**Item 5.****Development Application: 36 Union Street, Erskineville - D/2021/372**

File No.: D/2021/372

**Summary**

**Figure 21:** Proposed overshadowing at 9am on 21 June, extent of additional shadowing outlined in grey

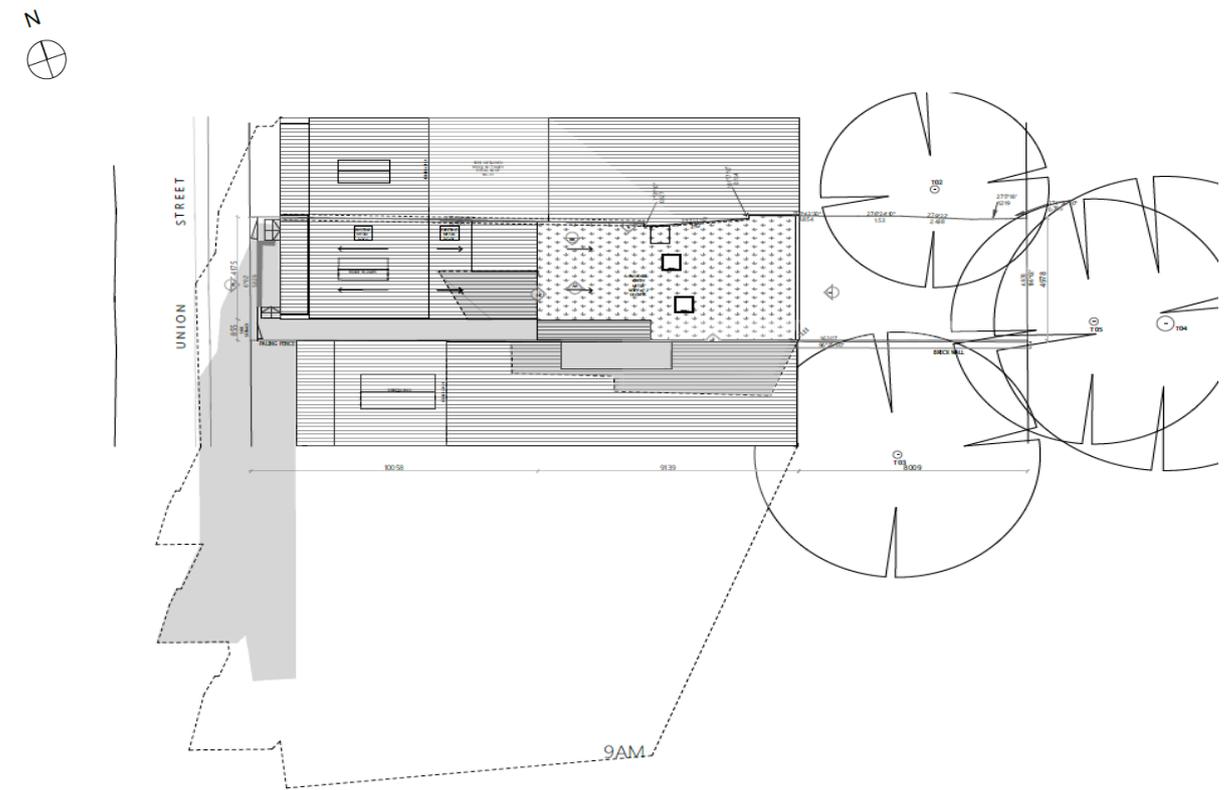
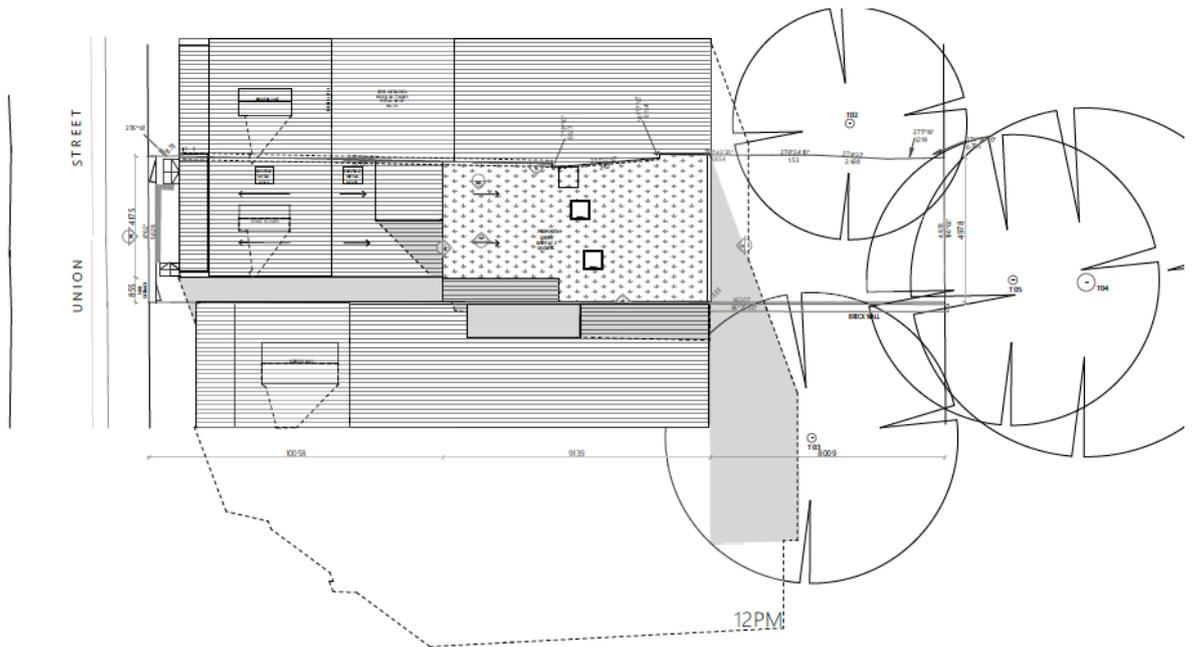
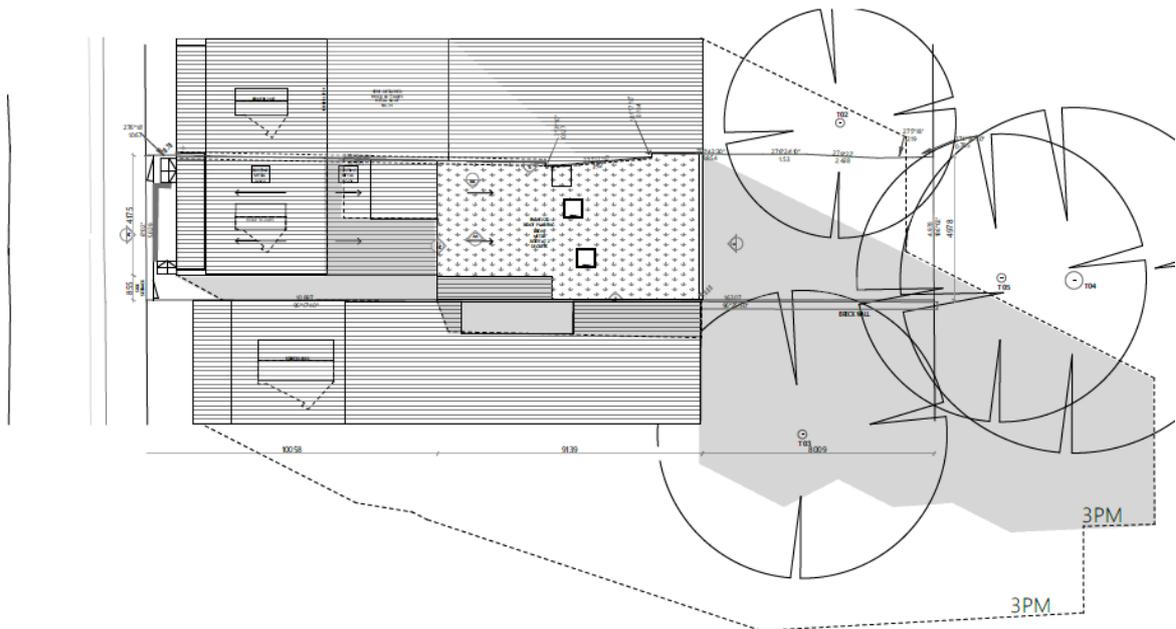
22. The Sydney DCP 2012 requires that development sites and neighbouring dwellings are to achieve a minimum of two hours' direct sunlight between 9am and 3pm on 21 June onto at least 1sqm of living room windows and at least 50 per cent of the minimum amount of private open space.
23. The application is accompanied by shadow diagrams which demonstrate the solar impact to the subject site and neighbouring properties. The proposed shadow diagrams at midwinter at 9am, 12pm and 3pm are provided in the figures below.

25. The proposal results in additional overshadowing to the properties to the south and east of the subject site at midwinter. The adjoining property at 38 Union Street receives in excess of two hours of solar access at midwinter to at least 8sqm of its private open space. This is achieved between 9am and 12pm on 21 June. The living room of 38 Union Street is located along the Union Street frontage and maintains two hours of solar access at midwinter to at least 1sqm of the living room windows.

26. The proposal results in additional overshadowing to the properties to the southeast (fronting Rochford Street) at 3pm. These properties maintain in excess of two hours of solar access at midwinter to at least 8sqm of their private open space. This is achieved between 9am and 12pm on 21 June.

31. As such, the overshadowing of the lightwell is considered acceptable in accordance with Part 4.1.3.1 of the Sydney DCP 2012.

**Figure 25:** Lightwell of 38 Union Street viewed from subject site showing location of rooms and windows

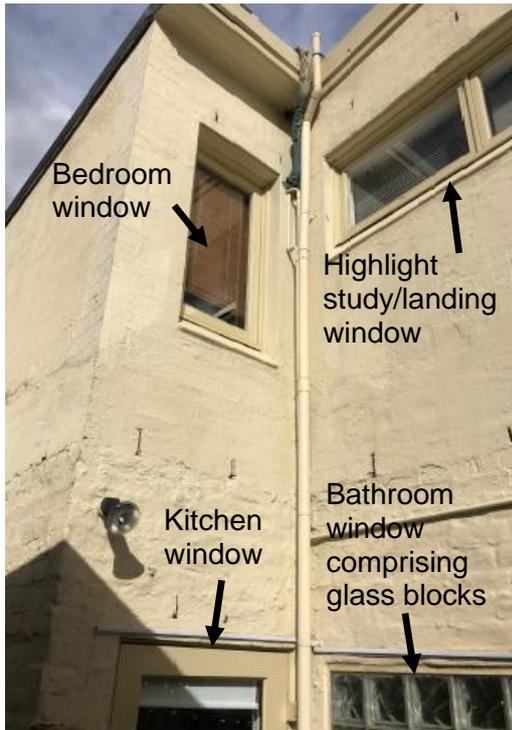
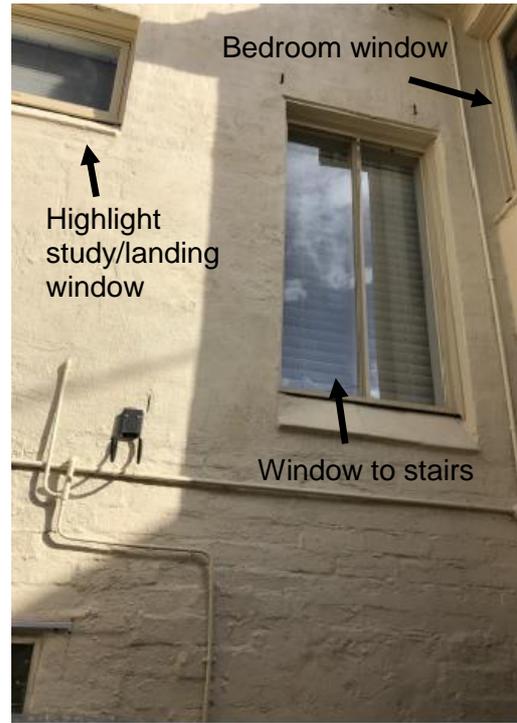
27. The proposal results in additional overshadowing to the lightwell of 38 Union Street, which is located beyond the southern boundary of the subject site. At midwinter, the proposal restricts solar access to the windows of the lightwell between 9am and 3pm. The location of the lightwell and its openings are shown in the figures below.

29. The side windows in the adjoining lightwell are located 1.16m from the shared boundary. As shown in the figures above, seven windows are located on the lightwell and provide daylight access to: the kitchen, study, bathroom (glass blocks provided to the lightwell), landing areas and bedrooms. However, in accordance with Provision 6 (b) it is noted that none of these rooms comprise the primary living area.

30. On this basis a setback of the ground floor adjacent to the lightwell is not required in this instance. It is noted that the first floor has been setback adjacent to the lightwell to provide a corresponding lightwell. While the proposal will reduce direct solar access to the lightwell, daylight will still be retained, and all rooms will continue to receive light and air through the lightwell.
